# Appendix F

## **Geotechnical Investigation**

**GEOLOGY AND SOILS REPORT APPROVAL LETTER**

TRACT: 7555  
BLOCK: 4  
LOTS: 3 - 9  
LOCATION: 650 - 674 S. San Vicente Boulevard

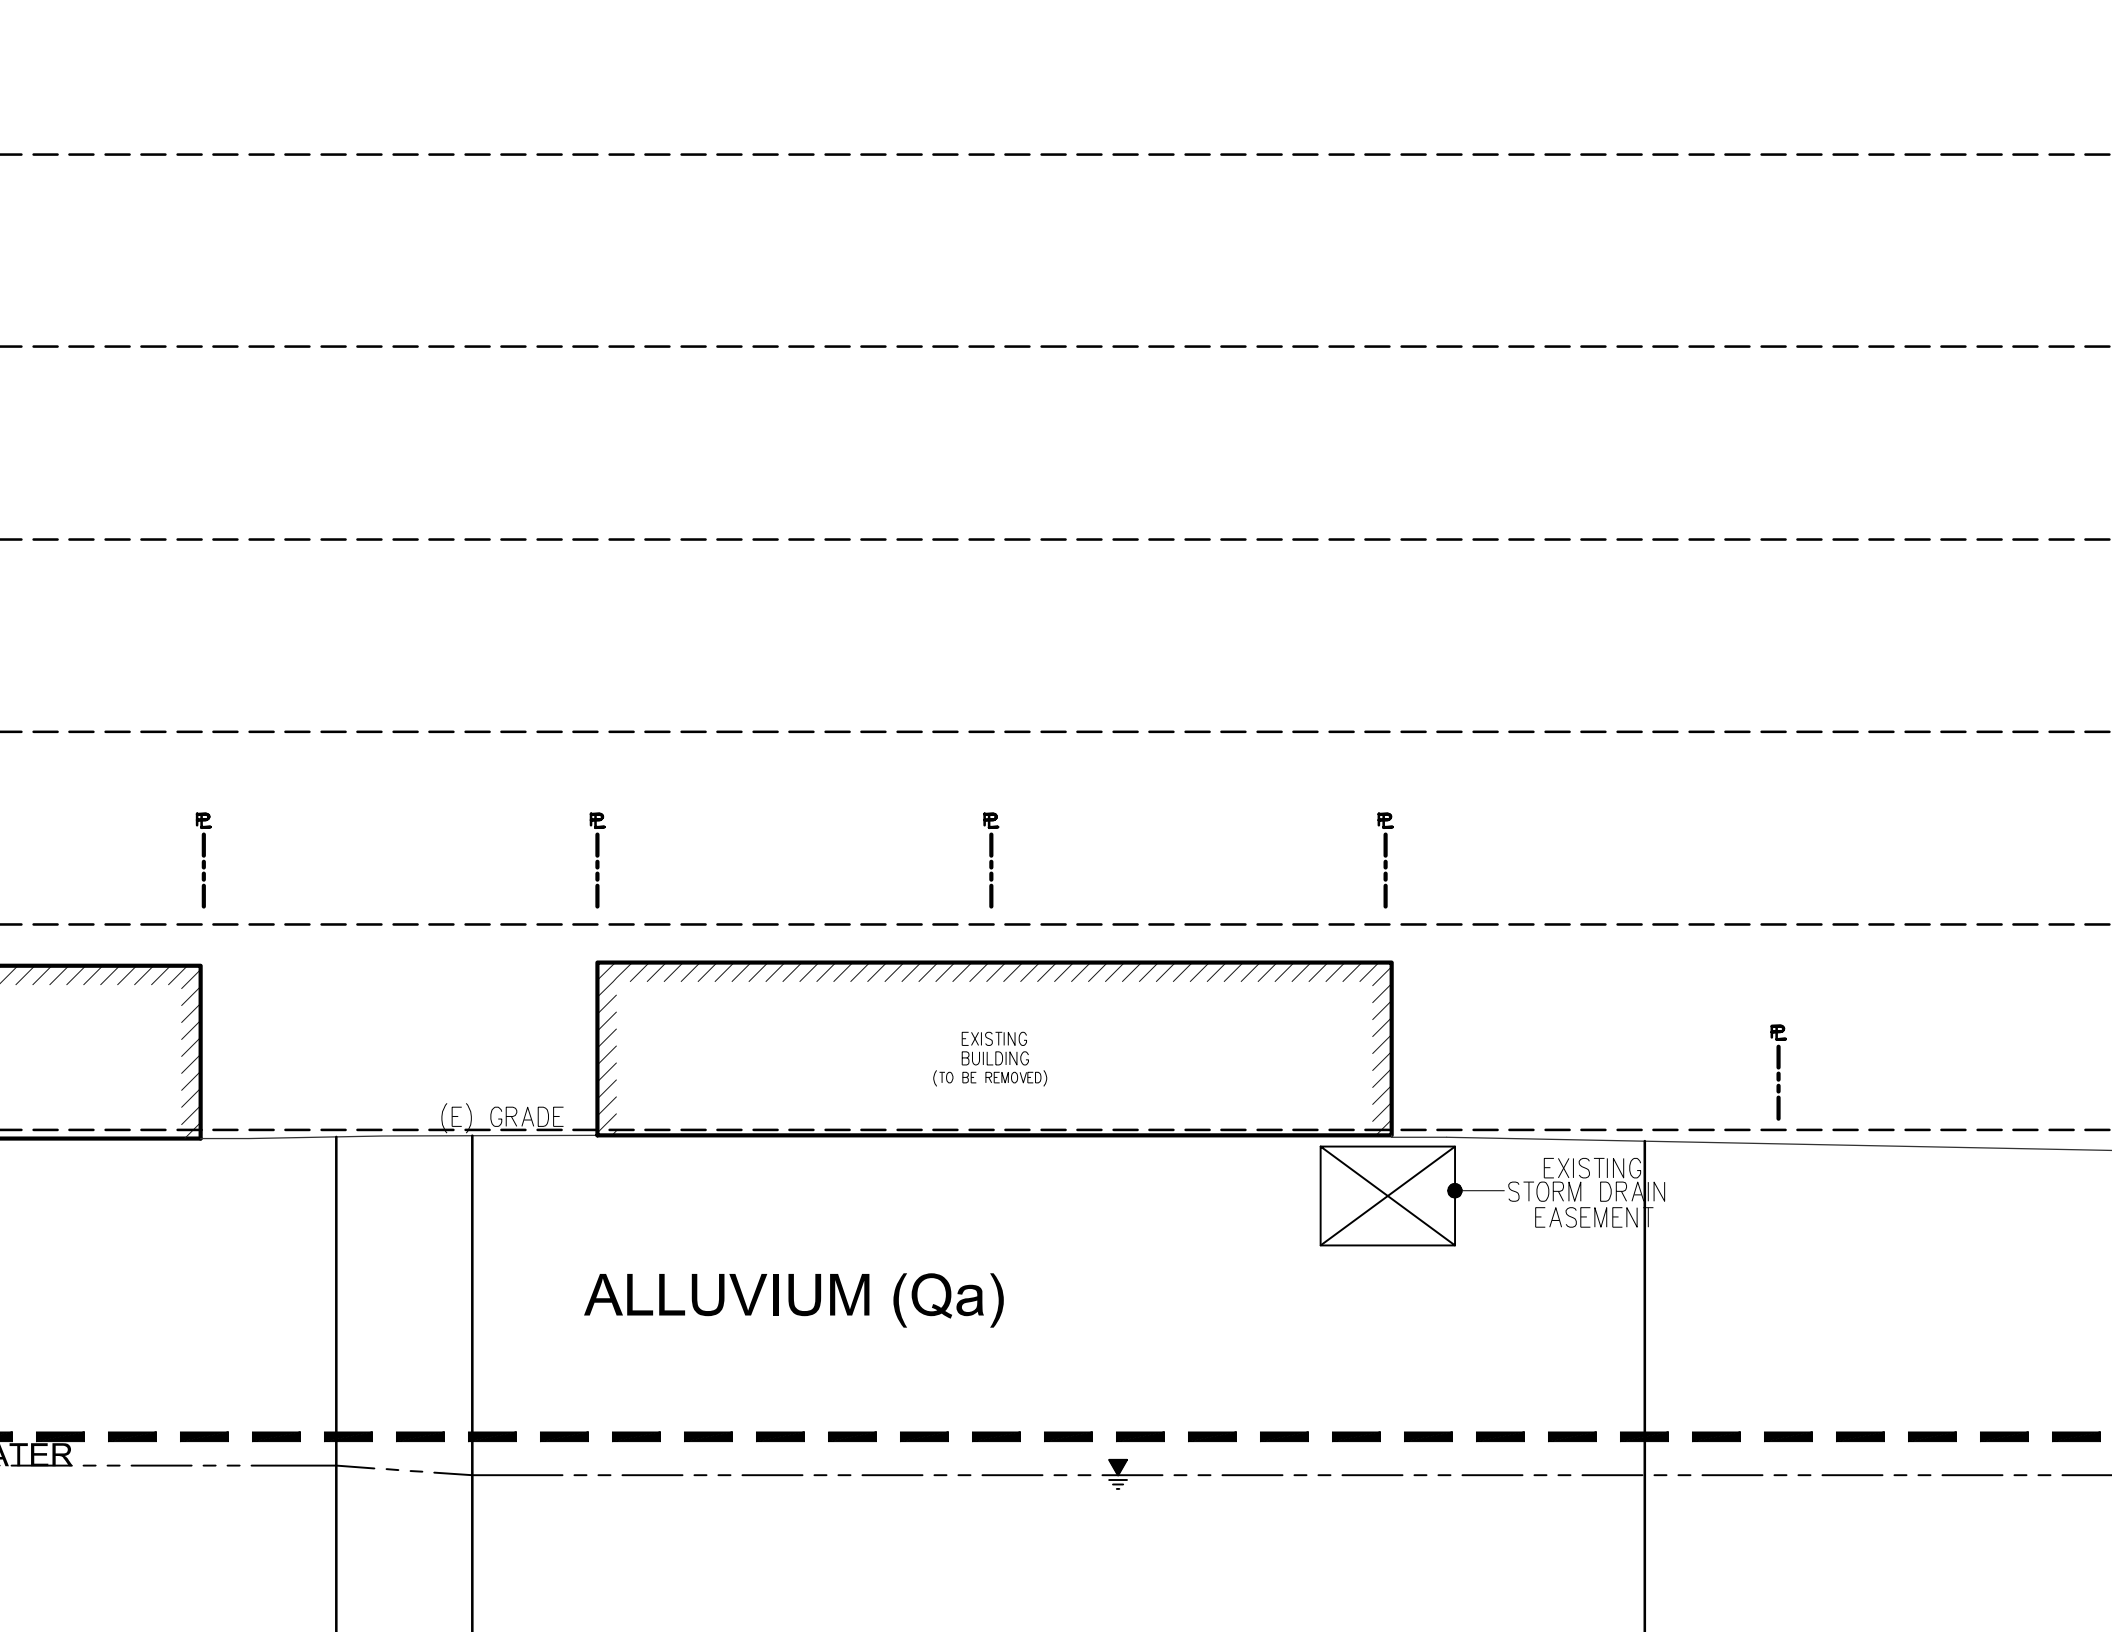
8. Obtain approval from the appropriate utilities concerning the proposed development. Note: The Site Plan and the City Navigate LA Maps show a storm drain easement at the Lot 4/Lot 5 boundary and, the approximate location of the Metro Line Tunnel is shown on Section B.
